SERVICE TEST
of
XM200 2.75-INCH AIRCRAFT ROCKET
LAUNCHER

Final Report
by
LTC John O. Gilliland
October 1969

SUBJECT: Final Reports, Engineering and Service Test, XM200 Rocket
Launcher for 2.75-Inch FPAR, USATECOM Project No.
4-ME-300-200-001/003

Figure 7. Rear view of XM200 showing wires damaged by rocket blast.

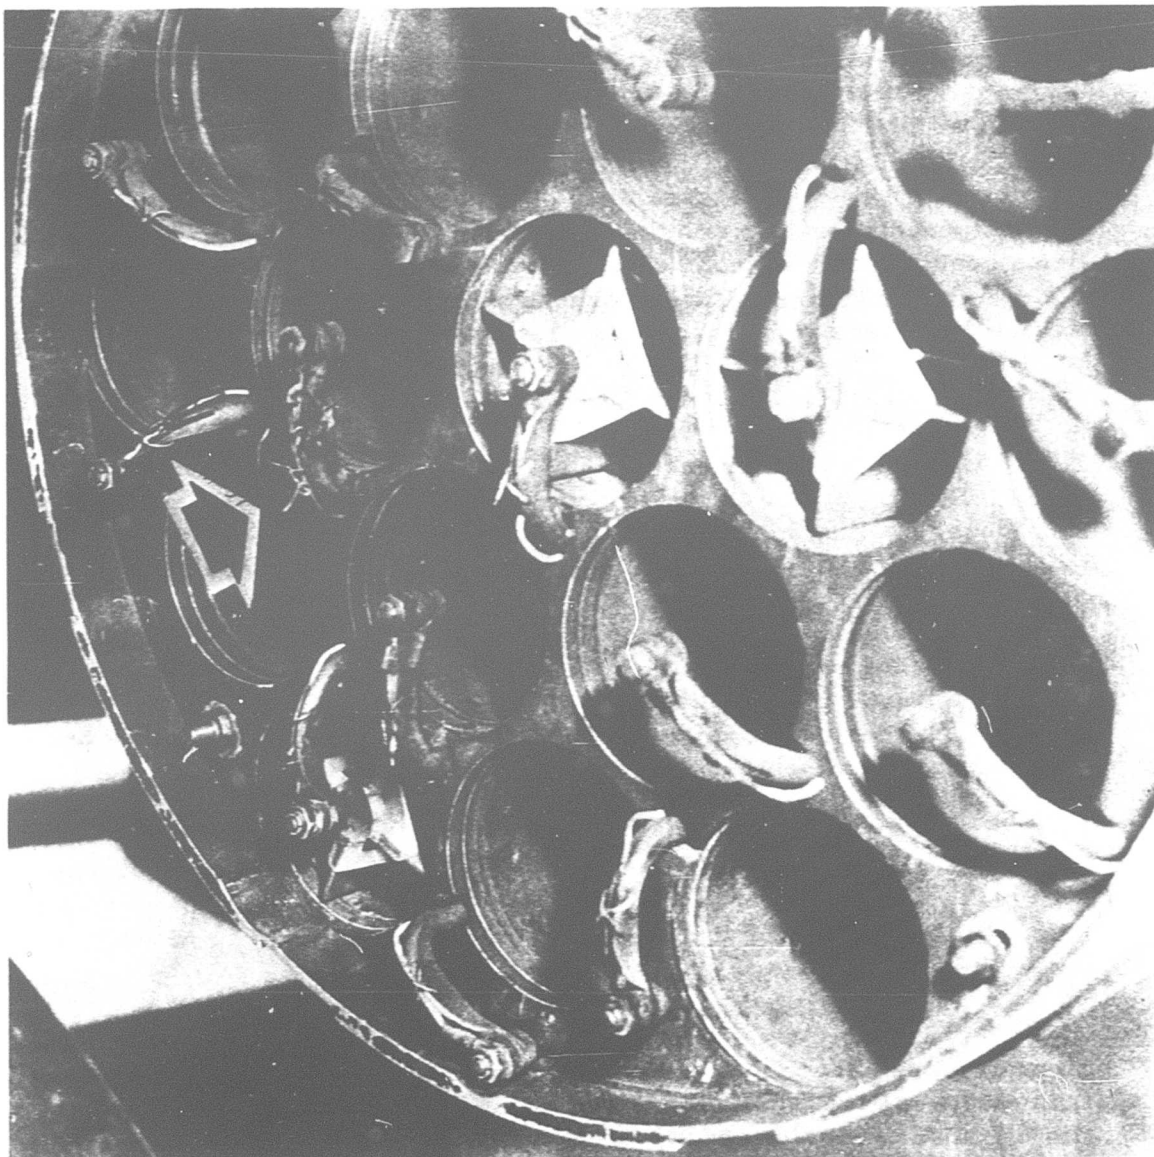
(b) The camming pin on the tube firing-arm detent assembly broke frequently during firing making the tube unusable.

The small pin which locked the contact shaft in the clear or armed detent broke on numerous occasions. The shaft required rotating when loading, arming, and unloading a rocket from the tube. Wear on the pin was caused during this operation; however, the pins were broken when the rocket was launched. This was attributed to the rocket blast. The pin could not be replaced. The tube and contact assembly required replacing, thus requiring partial disassembly of the launcher for outside tubes and complete disassembly for center tubes to correct the problems.

a. A stronger camming pin has been incorporated into the production launcher and there have been no reported failures of this pin during the IIT. Evaluation of this correction will be made upon review of the final IIT report.
